Product Improvement Program G08-109

SUBJECT: GROVE CRANE
PRODUCT IMPROVEMENT PROGRAM
iFLEX2 System Updates

AFFECTED: RT540E, RT600E and RT700E equipped with the iFLEX2
LMI System

FIRST DECAL PART NUMBERS

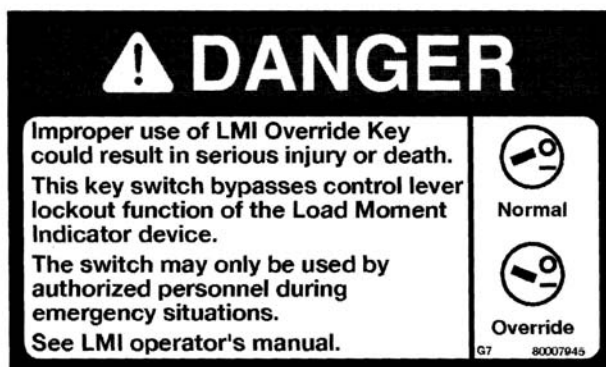
Order 2 new LMI override decals per machine. Attached to this PIP letter are decal specification sheets. You will need to select the proper decal part numbers depending on the language your machines decals are in. Using the attached illustration locate the decals and determine if the key switch orientation and decals match. If they match, no action is required and you may discard the unused decals. If they do not match, replace the existing decals with the new decals.

DECAL LOCATIONS IN CAB

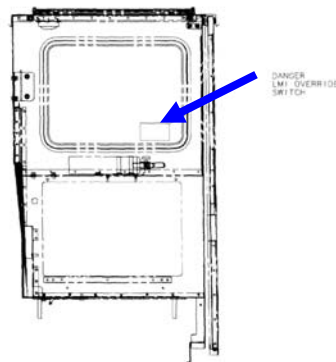
Manitowoc Crane Care has determined that the LMI Override key switch orientation and the corresponding decals may not correctly match on the affected units. Crane Care requests your assistance in checking the orientation of the LMI Override key switch to determine the accuracy of the corresponding decal.
